ADDITIONAL UPGRADES FOR LINCOLN THEATRE

Solicitation No.: DCAM-15-CS-0094

**Addendum No. 4
Issued: June 4, 2015**

BASEMENT FLOOR PLAN - NEW WORK - POWER SCALE: 1/8" = 1'-0"

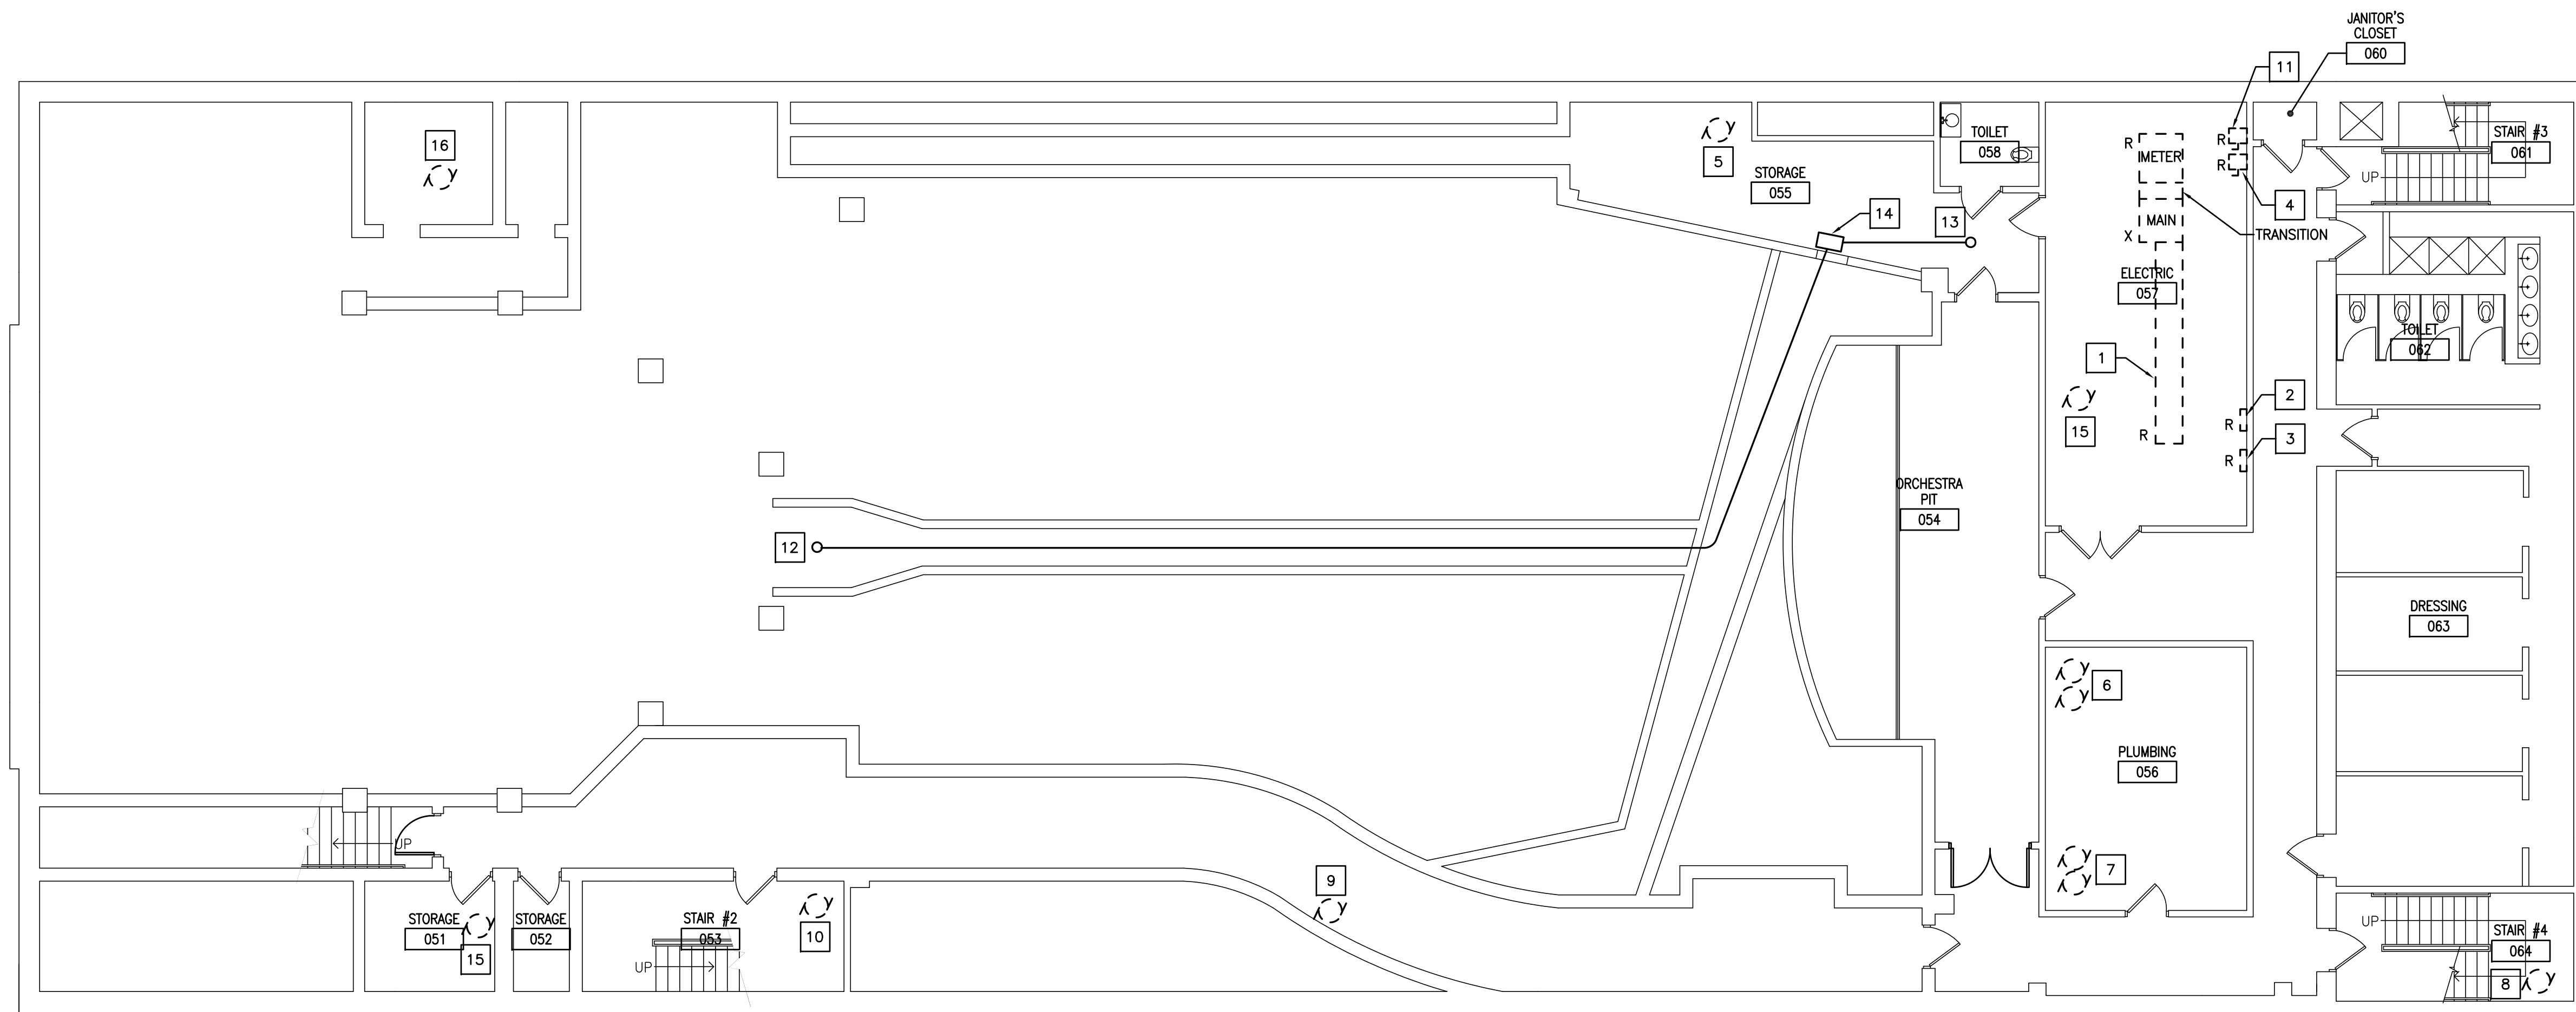
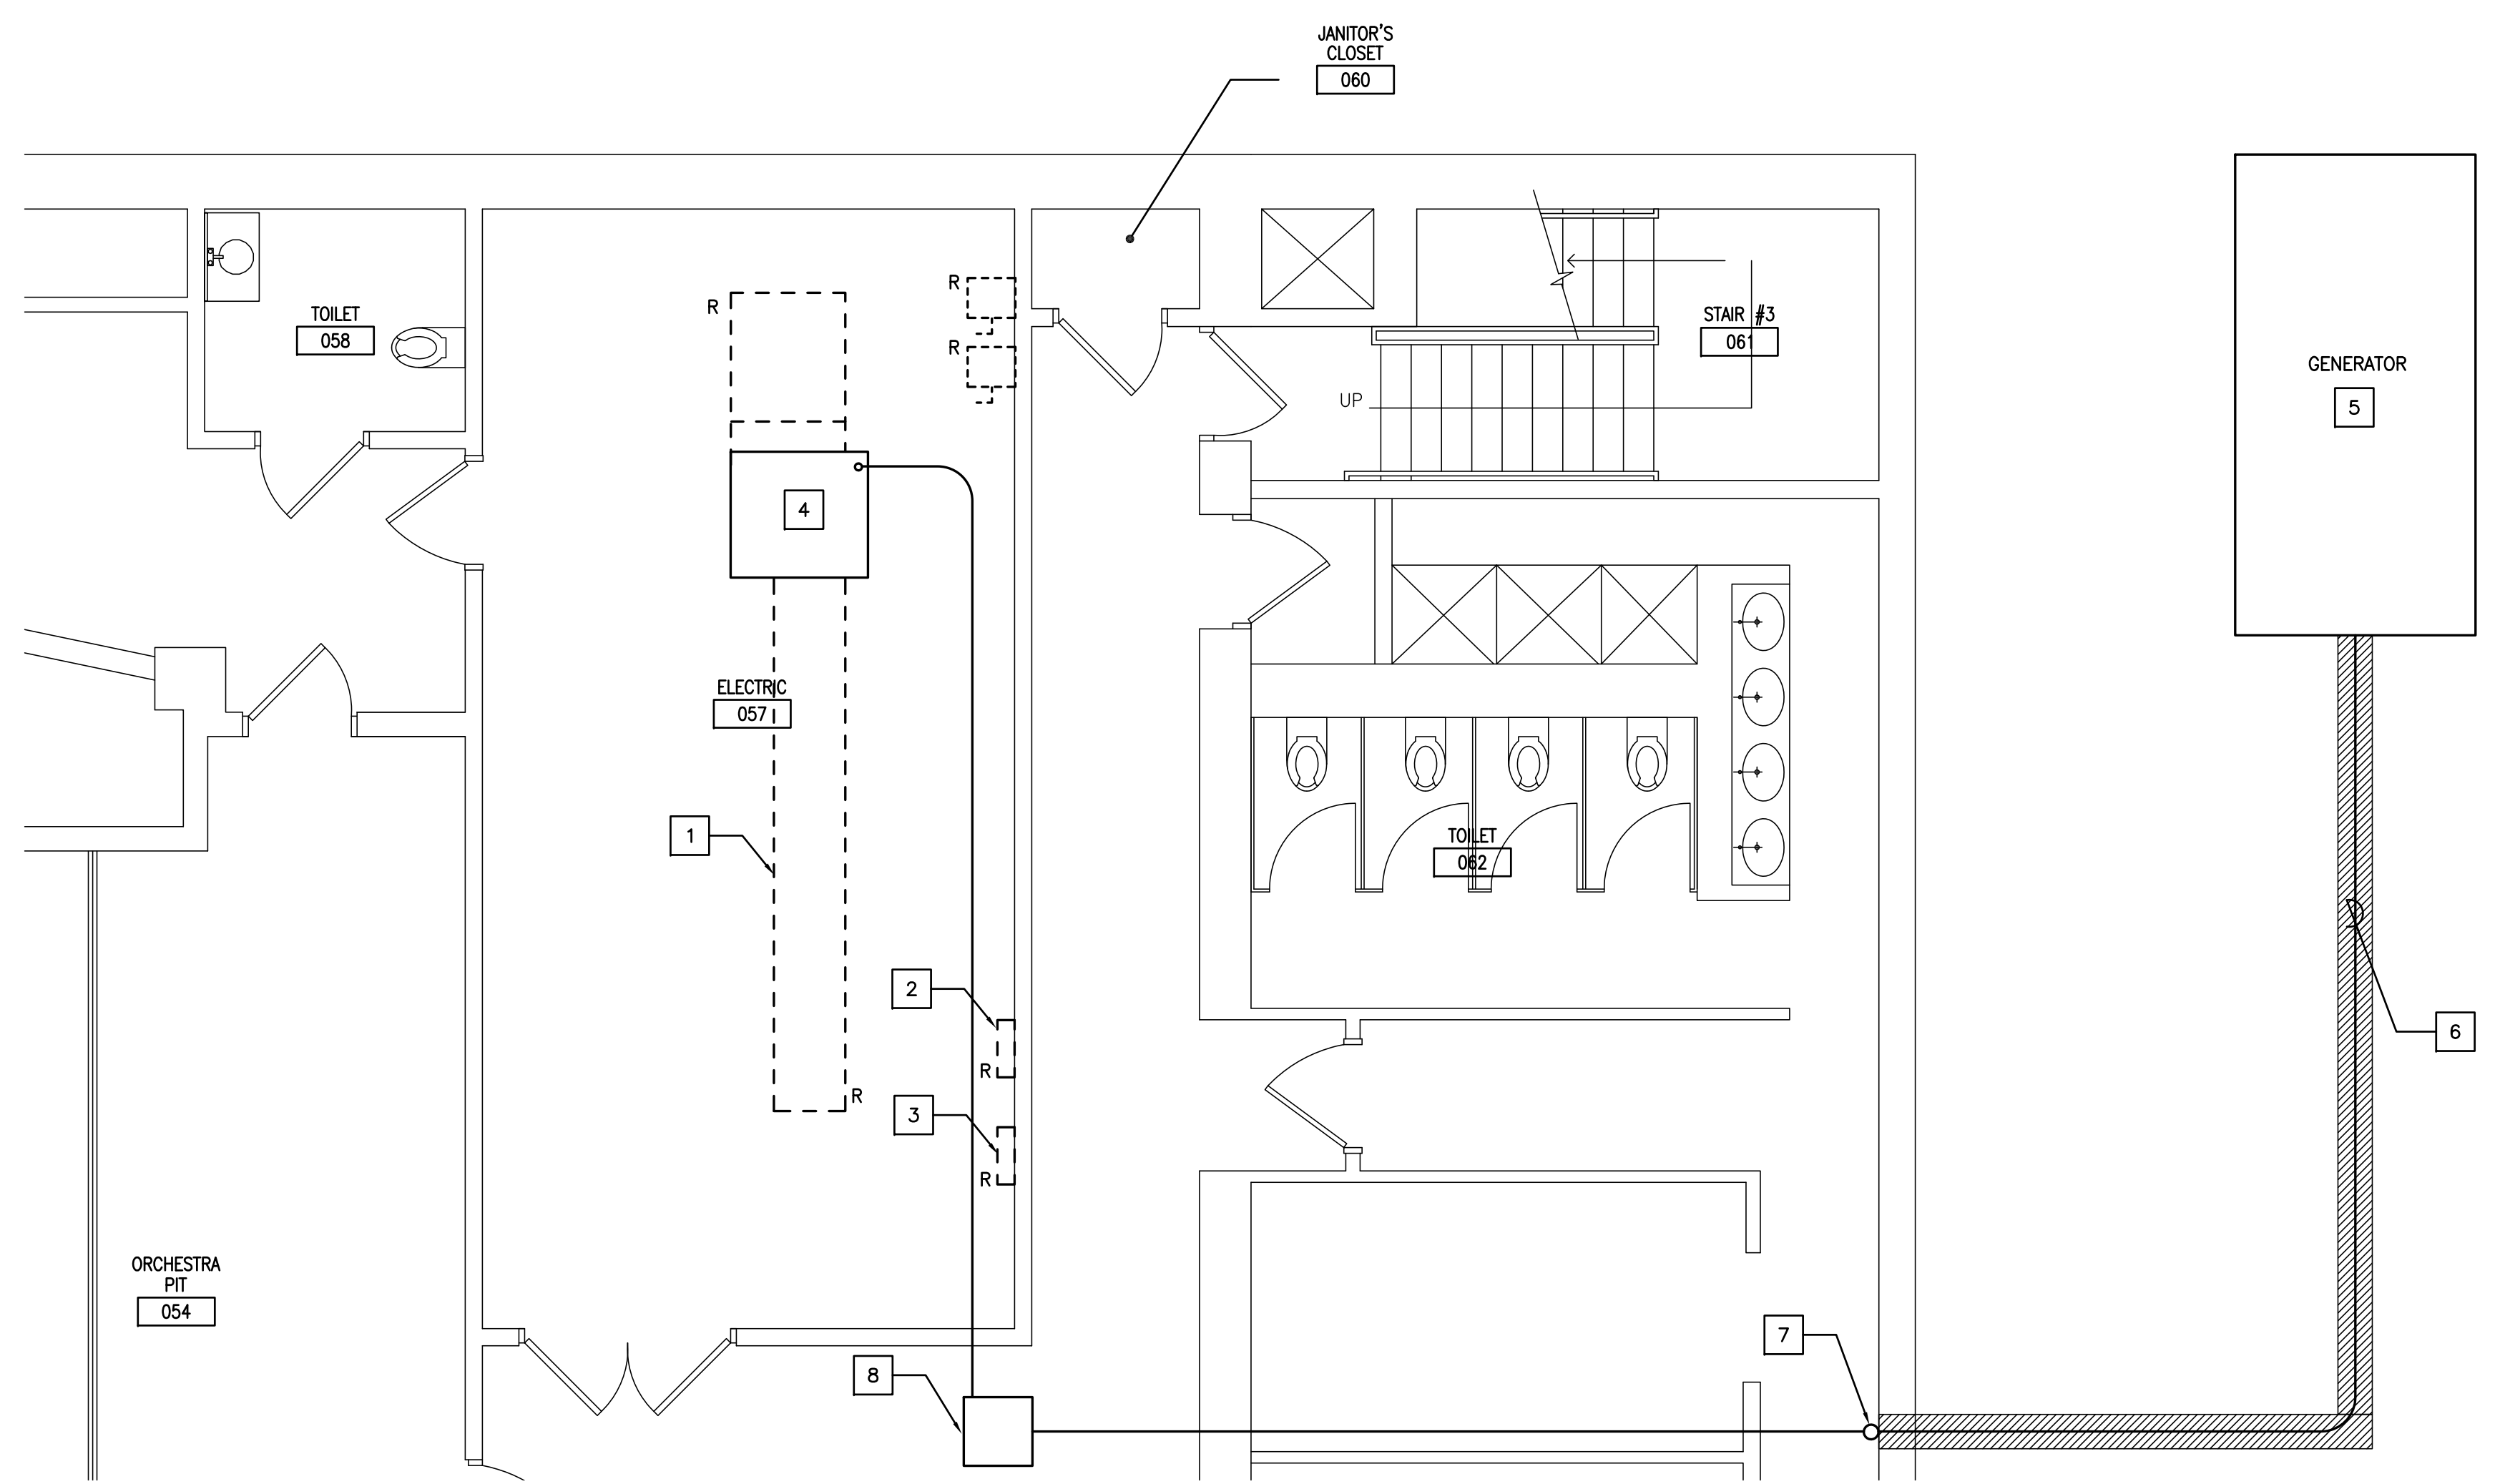
Revised drawings E105 and E106 with Rev.1 of 6/2/2015

- 5 NEW GENERATOR. FOR LOCATION SEE DWG. E106. BASIS OF BID IS 400KW/500KVA. SIZE IS BASED ON ENTIRE BUILDING PEAK DEMAND LOAD (APPROXIMATELY 300KW/375KVA BASED ON AVAILABLE BUILDING BILLS) INCLUDING 125% SAFETY FACTOR @90% CAPACITY. PROVIDE A 2P-20A, 208V CIRCUIT BREAKER AT THE AVAILABLE SPACE OF PANELBOARD 'LPB1' FOR GENERATOR JACKET HEATER, A 1P-20A, 120V CIRCUIT BREAKER AT THE AVAILABLE SPACE OF PANELBOARD 'LPB1' FOR GENERATOR BATTERY CHARGER, AND A 1" CONDUIT FOR GENERATOR CONTROLS. PROVIDE METERING FOR ONE MONTH (THIRTY DAYS) DURING PEAK SUMMER/WINTER, INFORM THE DESIGNER IN WRITING IF MAXIMUM AVERAGE PEAK LOAD IS LARGER THAN 300KW/375KVA. THE DESIGN INTENT IS TO HAVE THE GENERATOR CAPACITY SIZED AT 125% THE MAXIMUM AVERAGE PEAK LOAD AT 90% LOADING.

Please provide a FAACP drawing	Please see Drawings FB001 and FB101
6	B.1	Page 5 of the RFP, item “v” indicates to test the theatre electrical load & provide a backup generator. Please clarify as to what items are to be on the load of the electrical system for the generator, what type of generator (gas or electric), what size generator and where this generator is to be placed.	Refer to electrical contract documents for generator loads, type, and location. Provide load monitoring for one month during peak summer/winter season, to confirm anticipated building peak average load. For basis of proposal, provide: <ul style="list-style-type: none"> • A 500 kVA generator • 1600A ATS (in lieu of 1200A), and • 4 sets of (4-600 kCMIL, 1#4/0 G, 4” C) instead of 4 sets of (4-350 kCMIL, 1#3/0, 3”C) See Addendum 4, Item No. 2 for revised drawing E105

and E106, Revision 1 6/2/15.
		Also, we are assuming that the generator would be outside, if so, would it be enclosed with a fence? If so are there any specs for the fencing?	No fence is required for the generator set.
7	B.1	Page 5 of the RFP, item “w” indicates to replace the exhaust fans in certain areas. Please indicate what type of exhaust fan and the specifications as to the voltage, size, make and model type.	Refer to construction documents – details and schedules M-701.
8	B.1	The lighting drawing has this “RE” symbol that is not indicated on the drawings. What is this symbol?	Refer to drawing E001 for “RE” symbol definition
9		Is there an estimated price range from the government for this project?	No.
10	B.2	Please confirm the date of the drawings.	The date of the drawings is August 15, 2014.
11	B.2.2	Drawings show a 4000 amp Service for building with a Voltage of 120/208 (Need to verify Voltage), Specs call for a Service entrance rated switch, generator spec calls for a 300 KW Unit. Need to check what is needed,	Refer to response to Question #6.
